RE: Evans Mining Resource, DRMS File M-2024-056
112 Construction Materials Permit Application - Adequacy #3-5 Response

February 25, 2025 Adequacy Letter

March 13, 2025 Adequacy Letter

March 19, 2025 Letter

DETAIL 1 - TYPICAL SLOPES

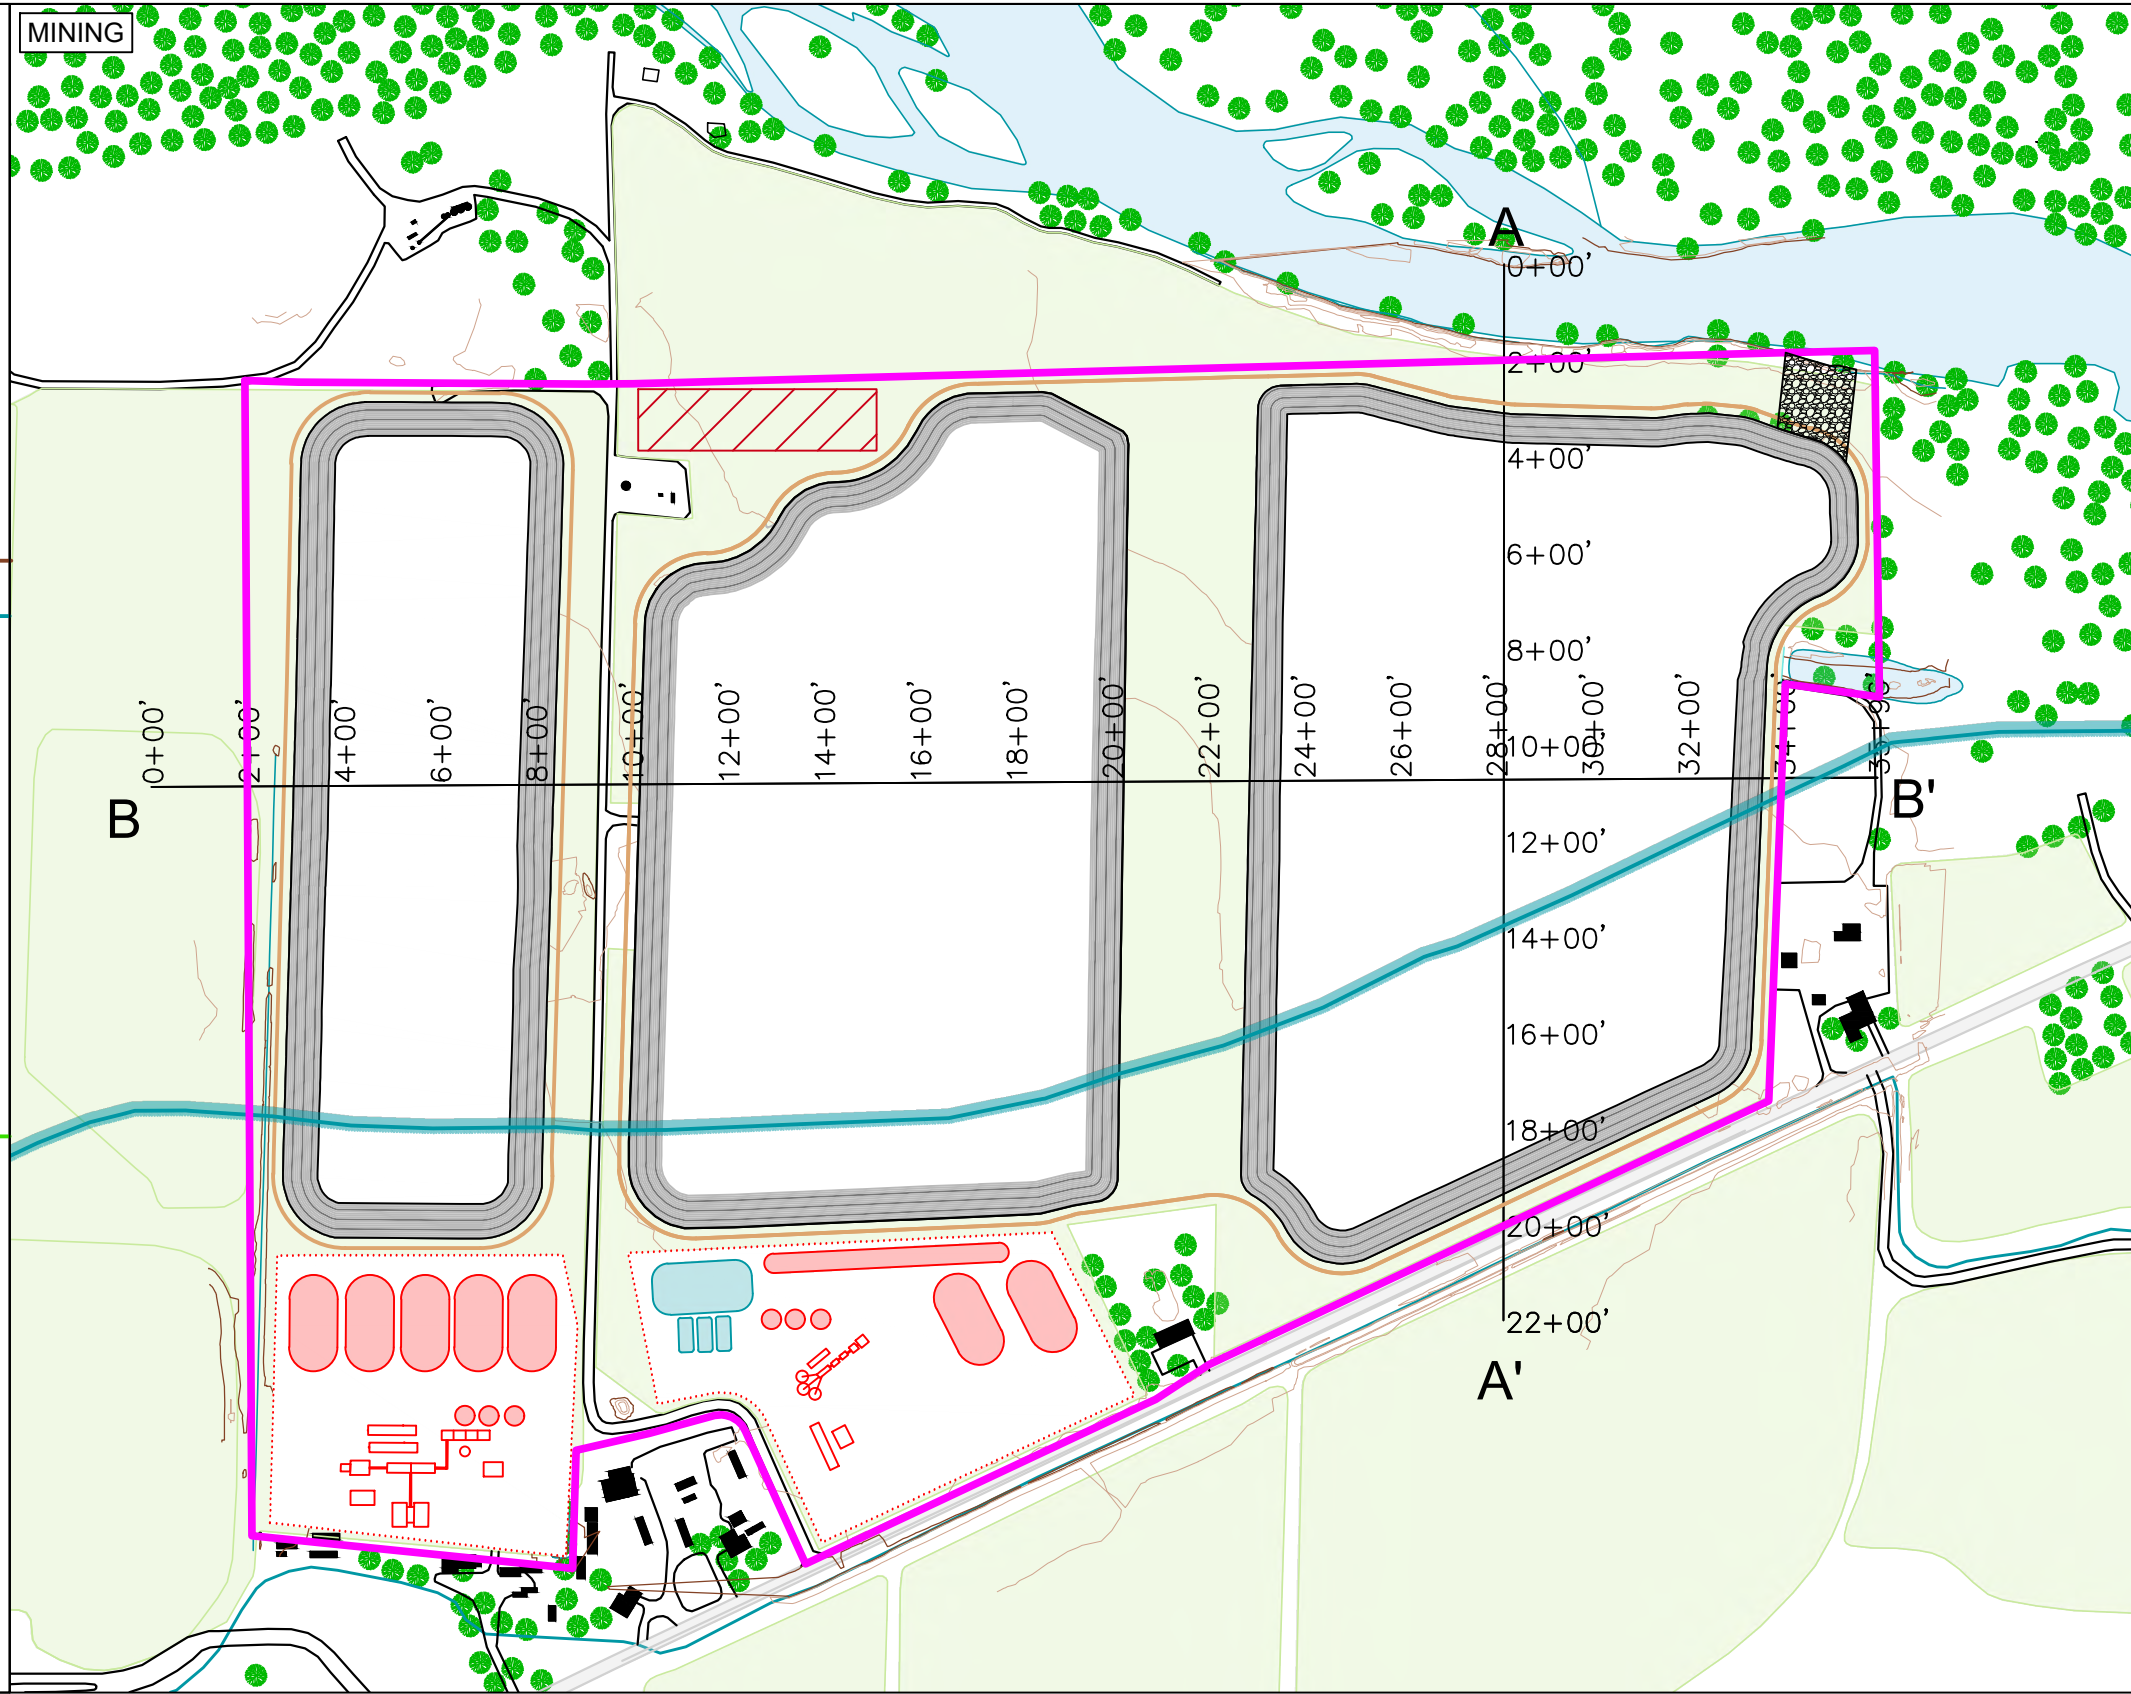
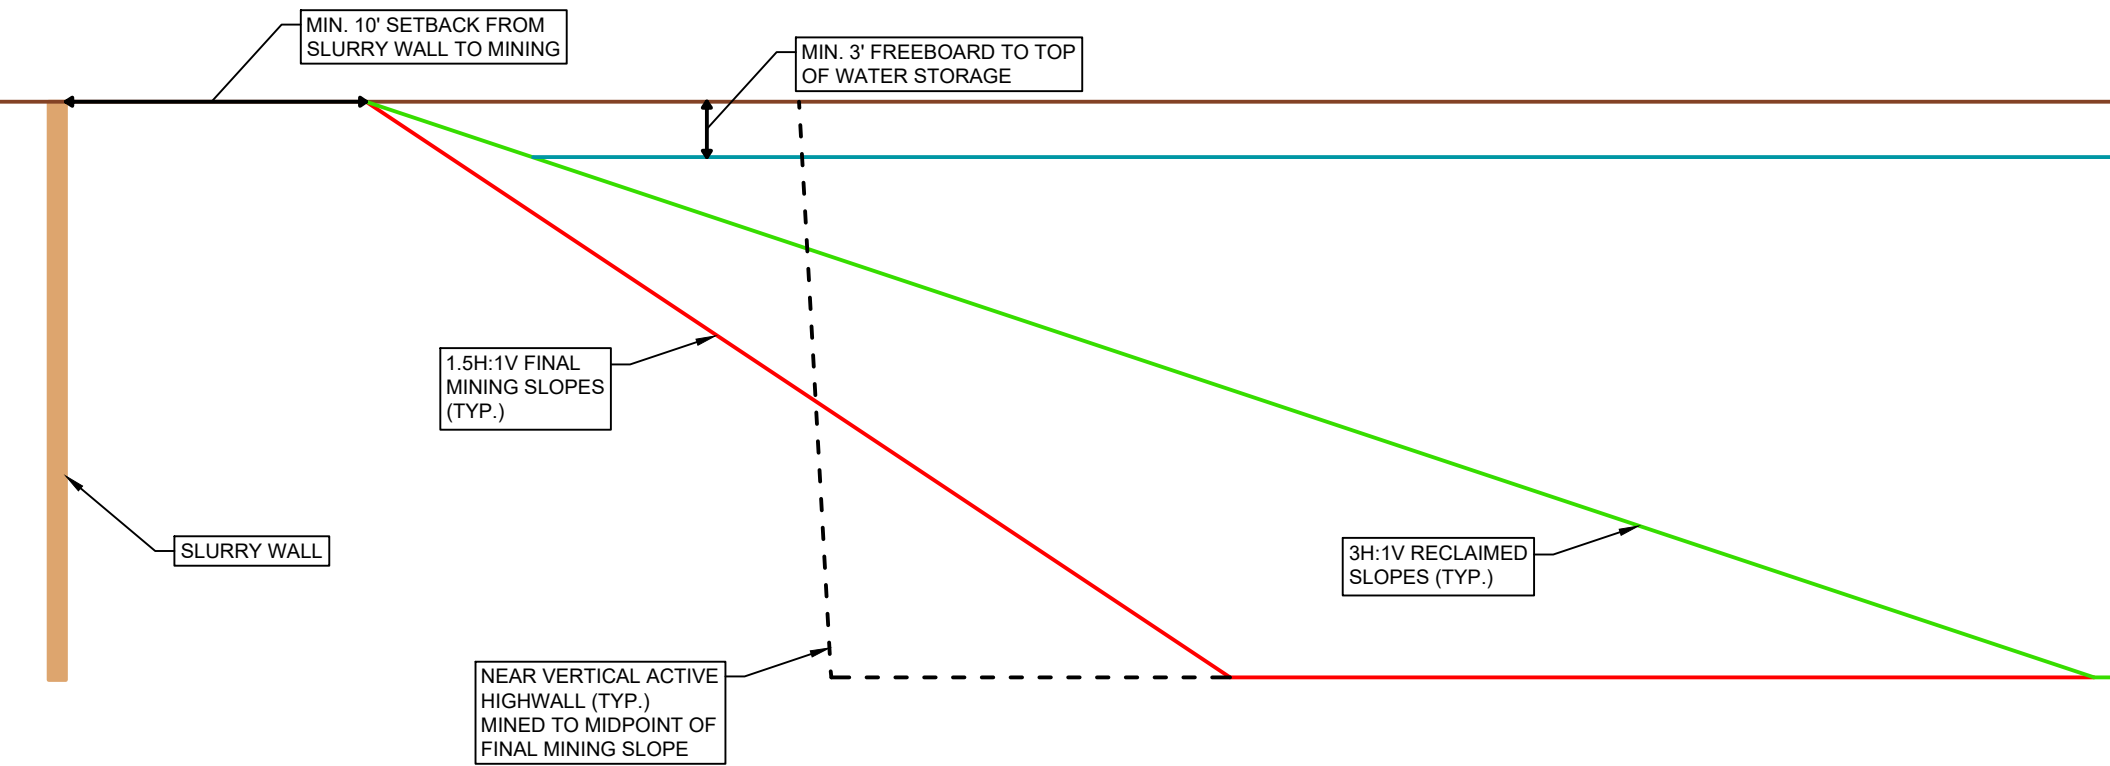
3. *Maps C-2, C-3, F-1, and G-1 depict the inlet/outlet structure in the northeast corner extending outside the permit boundary. Please redraw the permit boundary to show the entire structure within the affected acres and permit boundary and list the acres. If this changes the permitted acres, Per Rule 1.8.1, you will need to submit an amendment application to the Division and place a copy with the County Clerk and Recorder, prior to re-noticing the public for item #1 above. This will set a new decision date for the consideration of the application.*

The inlet/outlet structure location has been revised to stay entirely within the permit boundary. New maps showing the adjusted location are provided. The structure still maintains the same flood protection capacities.

FLOW STRUCTURE TYPICAL PROFILE

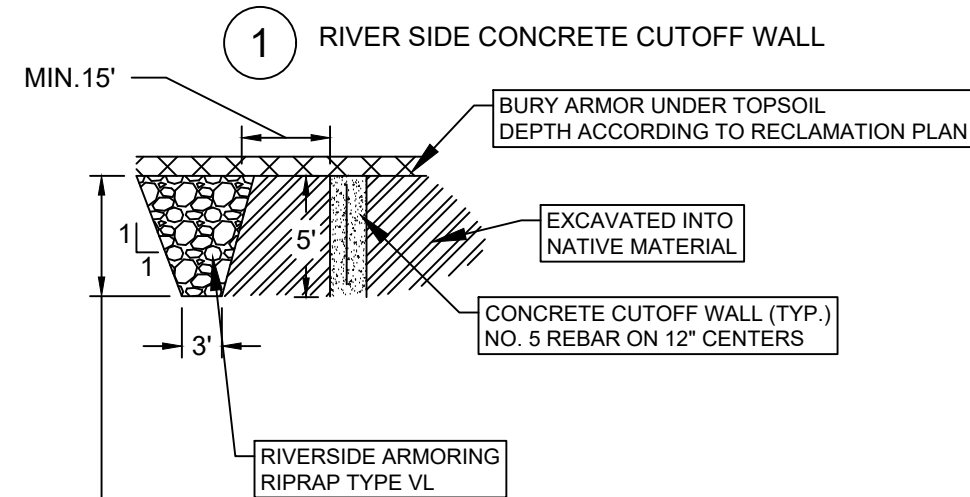
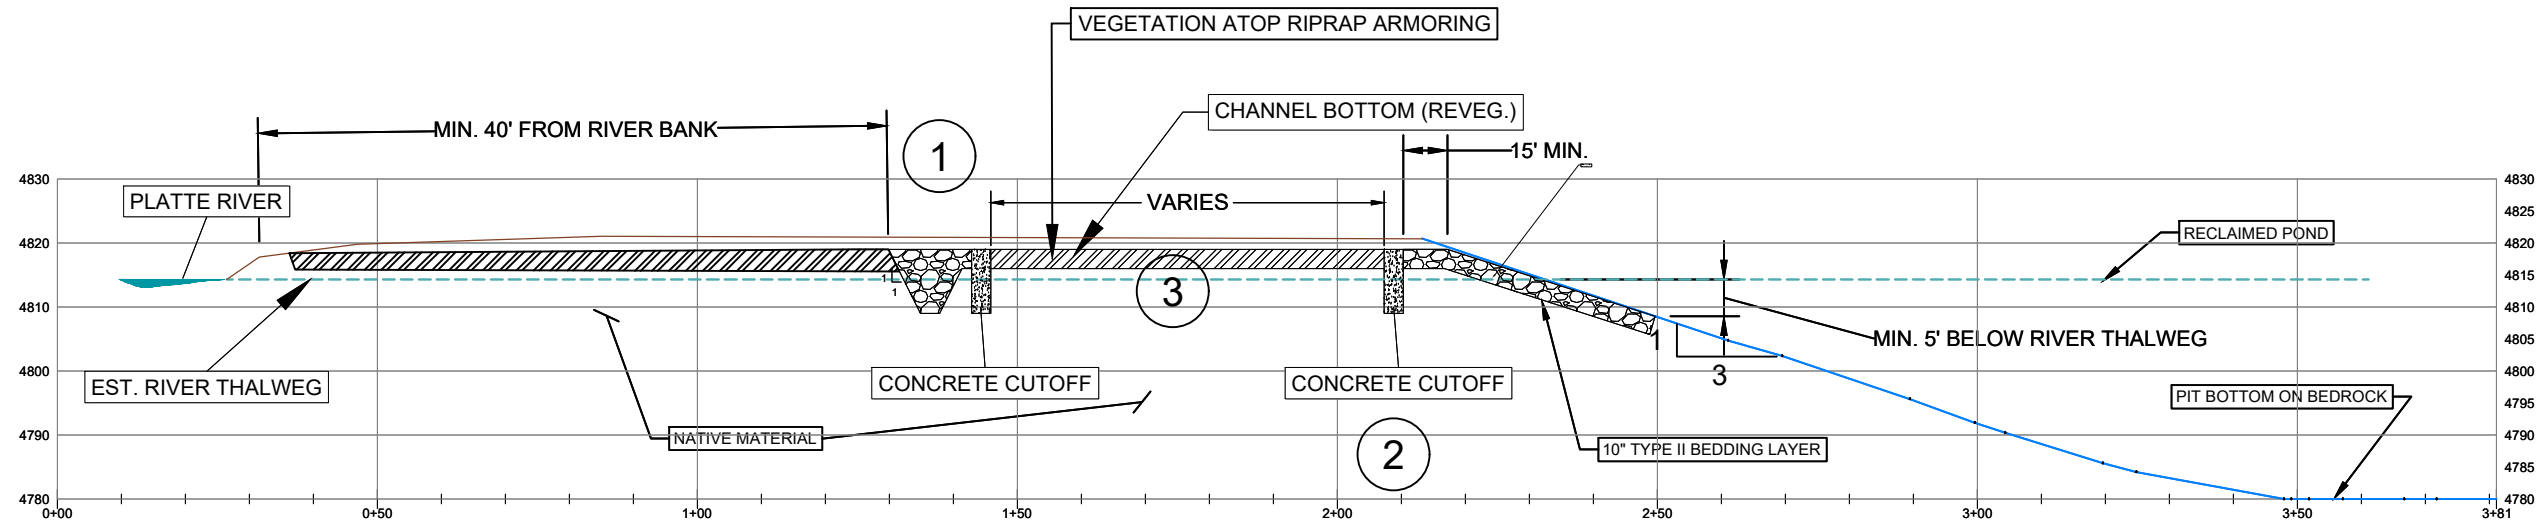
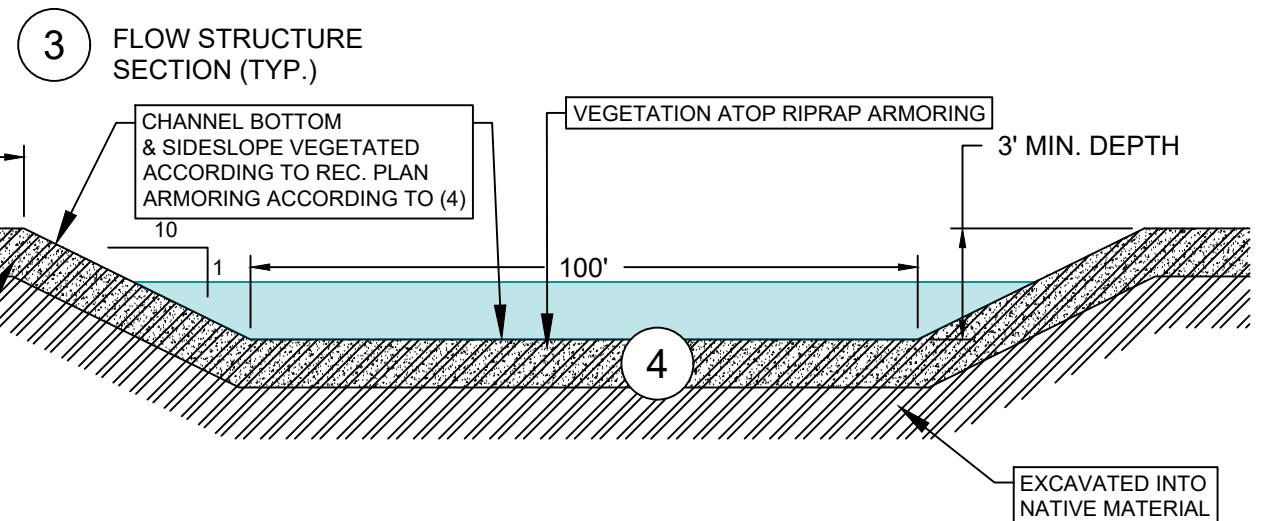
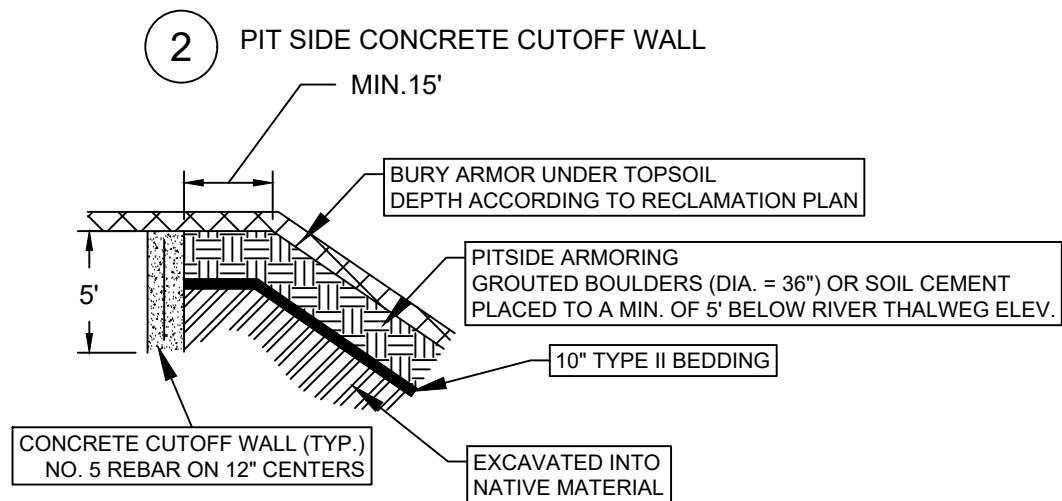
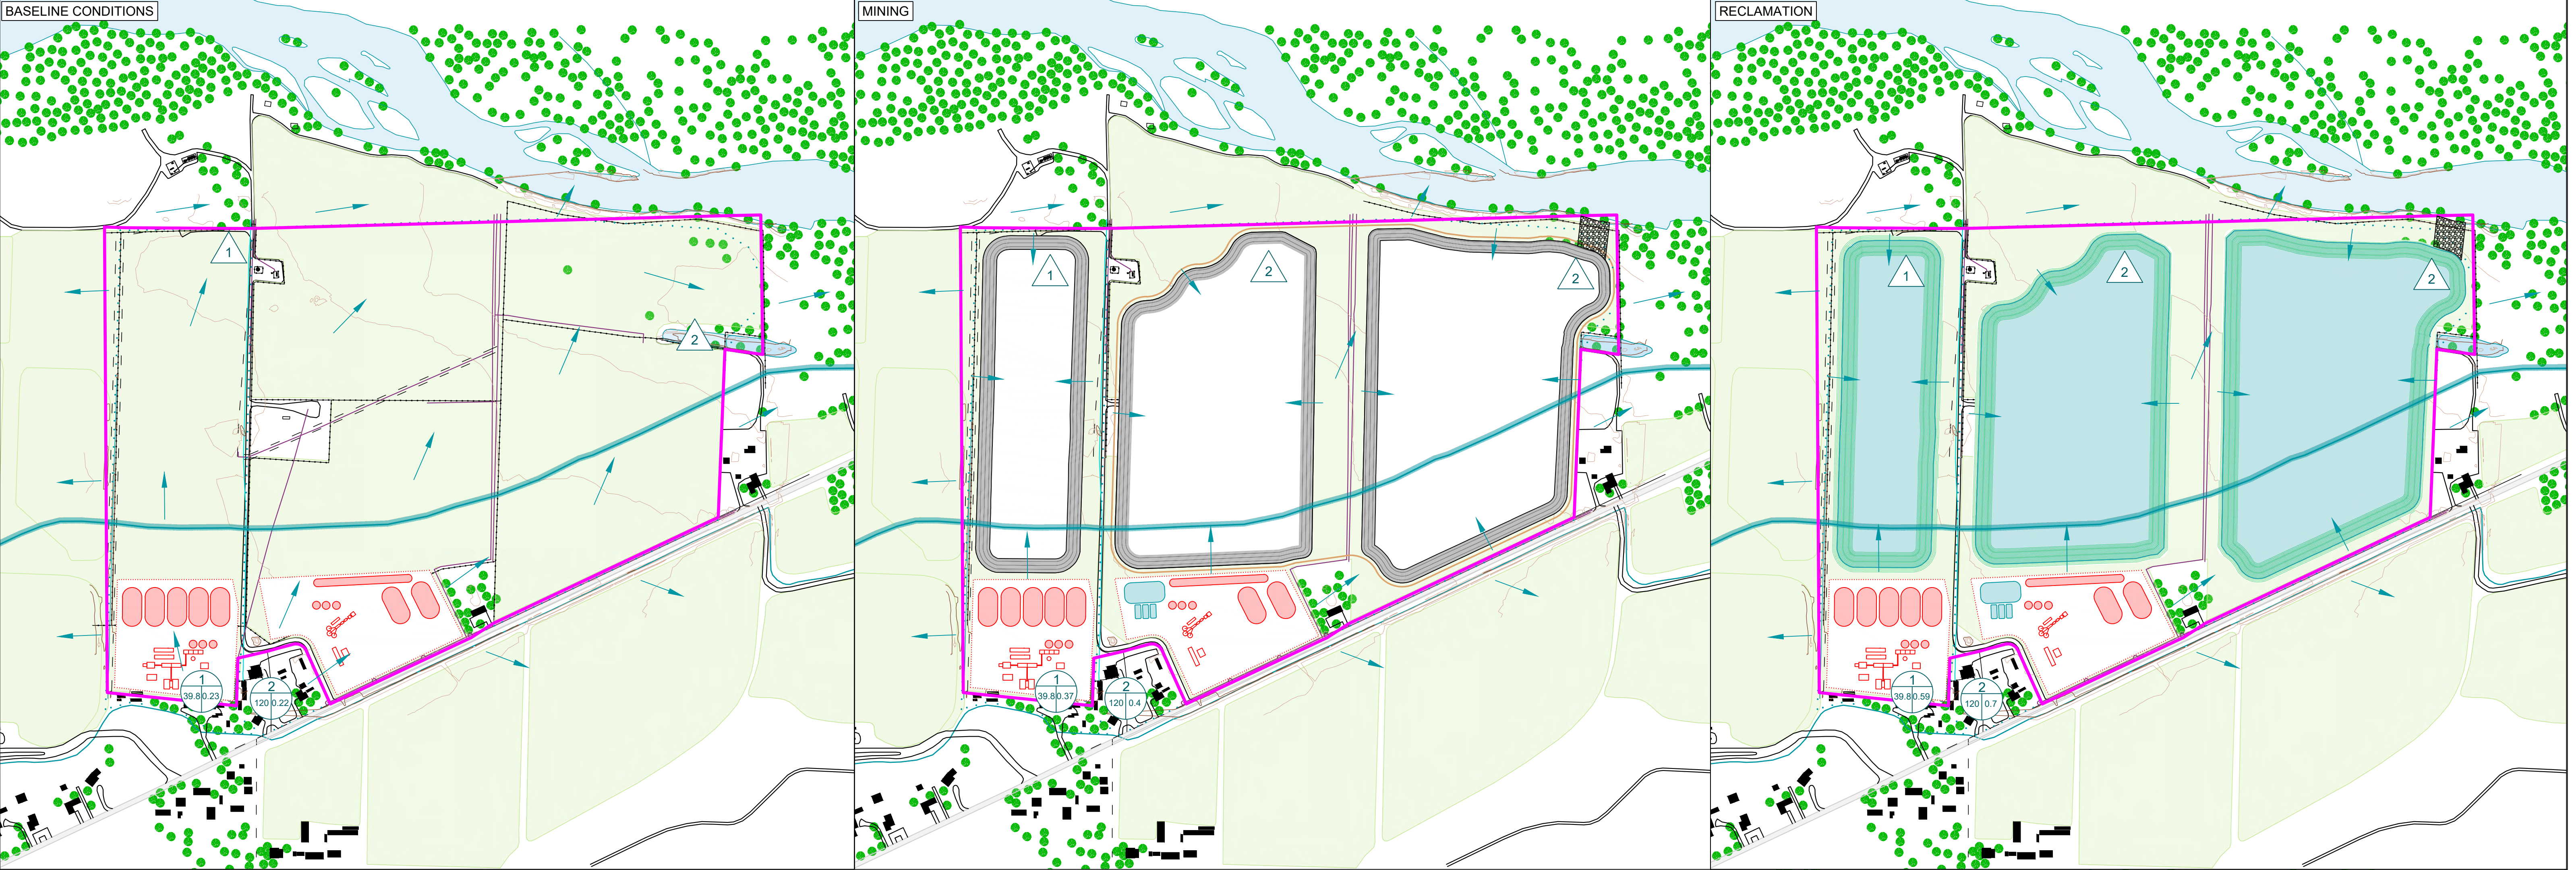
c. On the Flow Structures figure (Exhibit F-2), within the detail for the Pit Side Concrete Cutoff Wall, the label for pitside armoring states that "D50 = 48". The Applicant should indicate if this is correct. If it is correct, why are boulder-sized rocks proposed for this structure, rather than 6-inch riprap, as indicated in the notes of this figure?

The pitside armoring has been corrected. See the attached revised Map F-2.
